NRL Report No. B-1101
Metal Vacuum Type Relay submitted by General Electric Company

DATE 11 December 1934

NAVY DEPARTMENT
BUREAU OF ENGINEERING
Report on
Metal Vacuum Type Relay
submitted by
General Electric Company
Contracts NOs-33955 and NOs-34530

PROPOSED MODIFICATION OF
BREAKER MOUNTING

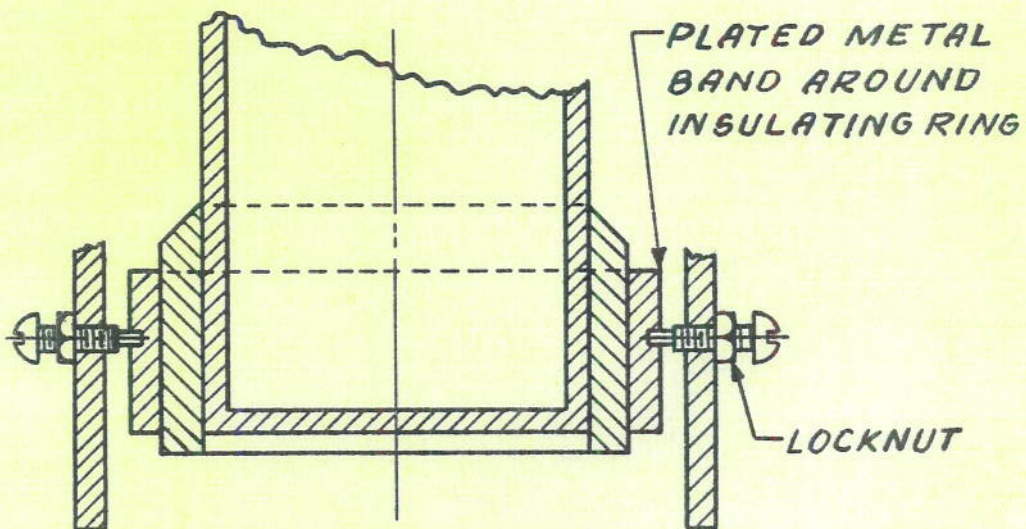
13. The relay complied with all of the requirements of the specifications with the exception of the shock test requirement. When given 13 blows of 150 foot pounds on a Navy standard shock machine, the relay failed to operate satisfactorily. An examination disclosed that the screws securing the breaker were loose in the insulating ring.

14. For proper operation the metal vacuum breaker should be rigidly mounted. A sketch of a proposed mounting is shown on Plate 2.

(a) It is recommended that this relay be approved for use on Contracts NOs-33955 and NOs-34550, providing the manufacturer changes the mounting of the metal vacuum breaker. A sketch of a proposed mounting is shown on Plate 2.
